Contract #: 04-0120F4Cty: SF/ALA Rte: 80 PM: 13.2/13.9File #: 69.25B**QUALITY ASSURANCE -- NON-CONFORMANCE REPORT****Location:** Changxing Island, Shanghai, PRC**Report No:** NCR-000322**Prime Contractor:** American Bridge/Fluor Enterprises, a JV**Date:** 15-Jun-2009**Submitting Contractor:** Zhenhua Port Machinery Company, Ltd (ZPMC), Changxing Island**NCR #:** ZPMC-0296**Type of problem:**

Job Name: SAS Superstructure

Subject: NCR No. ZPMC-0296

Reference Description: Backing Bars / South Shaft Lift 1 / 43m & 47.6m Diaphragm CJP Welds

Reference Description: Missing backing bars on diaphragm corner piece welds in South Tower, Lift 1**Description of Non-Conformance:**

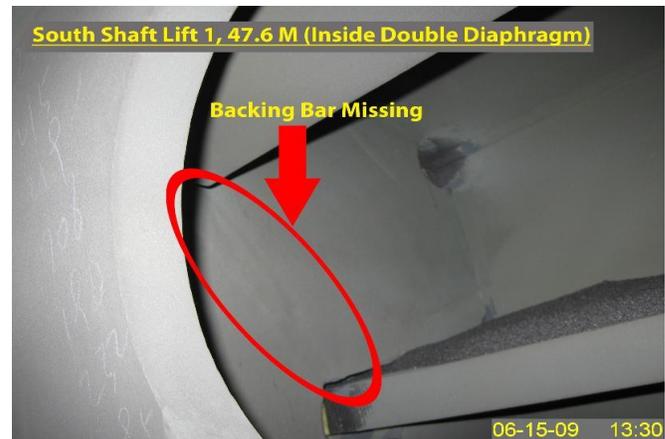
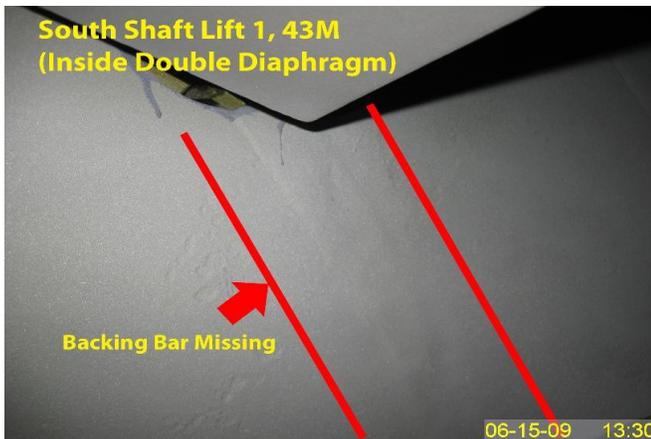
During random visual after blast inspection of South Tower, Lift 1, QA observed that there are no backing bars on diaphragm corner piece welds SSD1-A164H/J-194 & SSD1-A164G/J-215. These welds were previously accepted by ZPMC QC Personnel.

Weld Joint Detail WT-63 specifies backing bar.

The proposed resolution is not acceptable. Weld detail WVT-63 shown on the approved shop drawings for this weld includes a backing bar. For future welds where the backing bar will be removed, please notify the Engineer.

However, this NPR (ABF-NPR-000313R01) does not address the Quality Control issue with regard to the missing backing bars. In addition, please provide documentation of the steps taken by the Quality Control Manager to prevent future occurrences.

WELD NUMBER: SSD1-A164H/J-194

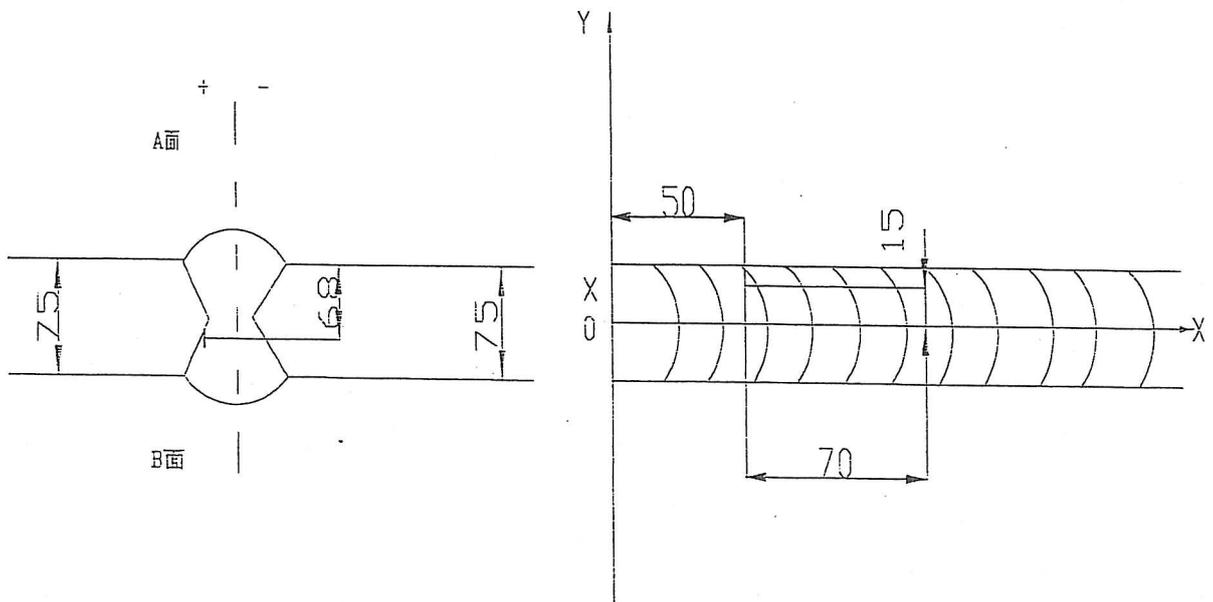
Rejected indication found by ultrasonic inspection is less than the maximum allowance aggregate length.

- 1、 碳弧气刨, 焊接接头没有有效打磨;
 - 2、 起弧和收弧没有交错布置, 以减少熔渣最少到最少;
 - 3、 保温层没有有效的清理。
1. The weld joint was not ground sufficiently after arc-gouging.
 2. The arc starts and stops were not staggered to minimize slag entrapment.
 3. Interpass cleaning was not performed properly.

- 1、 Gouge off the defect weld;
- 2、 Grind smoothly the gouged surface;
- 3、 If User's request, check with VT or other NDT method to make sure the defect remove completely;
- 4、 Preheat and the interpass temperature control according to the relative WPS-repair;
- 5、 Check the welding according to the approved shop drawing.

WELD NUMBER: SSD1-A164GJ-215

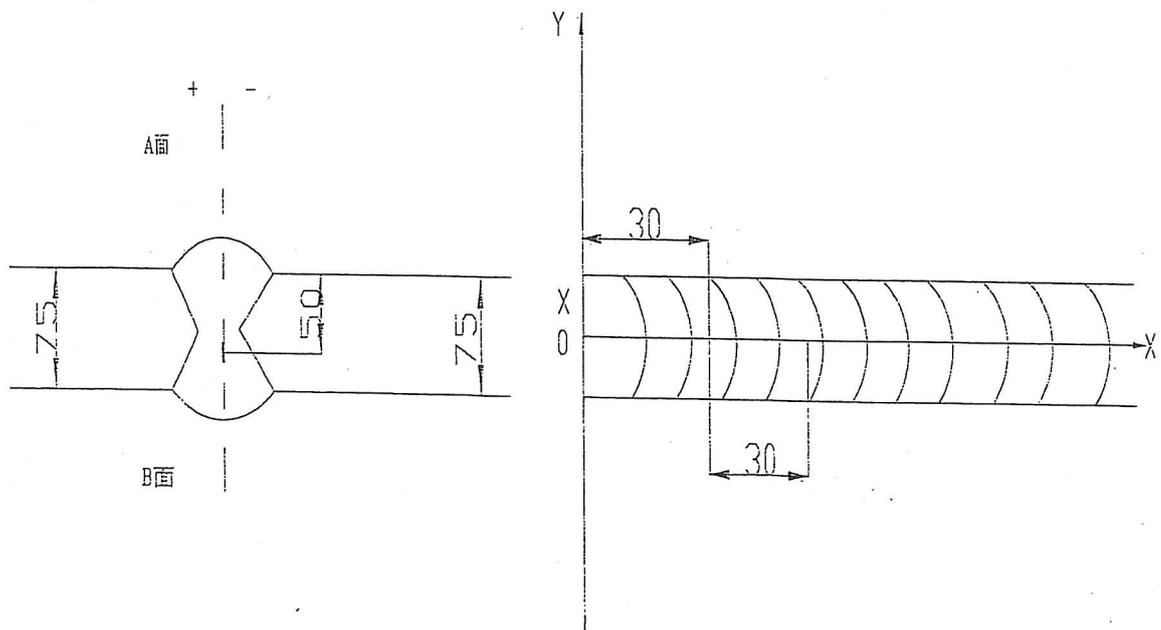
Rejected indication found by ultrasonic inspection is less than the maximum allowance aggregate length.

1. 电弧引弧时没有有效打磨。
 2. 起弧和收弧没有交错布置,以将焊缝减少到最少。
 3. 焊缝间没有有效的清理。
1. The weld joint was not ground sufficiently after arc-gouging.
2. The arc starts and stops were not staggered to minimize slag entrapment.
3. Interpass cleaning was not performed properly.

1. Gouge off the defect weld;
2. Grind smoothly the gouged surface;
3. If User's request, check with VT or other NDT method to make sure the defect remove completely;
4. Preheat and the interpass temperature control according to the relative WPS-repair;
5. Check the welding according to the approved shop drawing.

Reference Description: Backing bars with intermittent fillet welds in South Tower, Lift 3

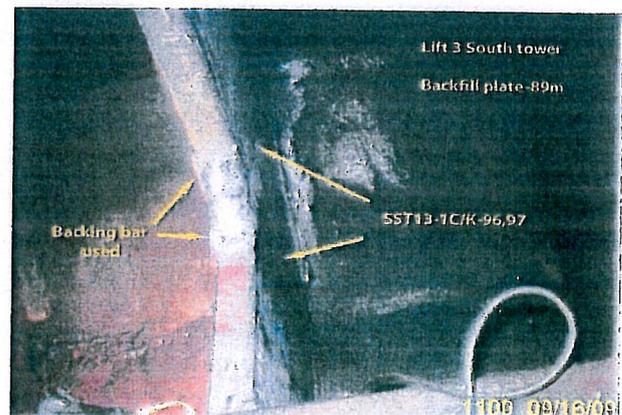
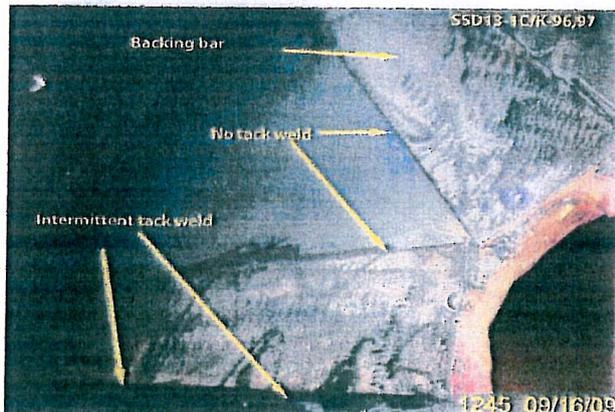
During Ultrasonic Testing (UT) of the South Tower, Lift 3 welds SST13-1C/K-96 & 97, QA discovered that backing bars have been attached with intermittent fillet welds outside of the weld joints. These weld joints were previously tested and accepted by ZPMC Quality Control Personnel.

AWS D1.5-2002, Section 3.3.7.6 - "Tack welds used to attach steel backing and placed external to the weld joint shall be made continuous by fillet welding for the full length of the backing or shall be removed."
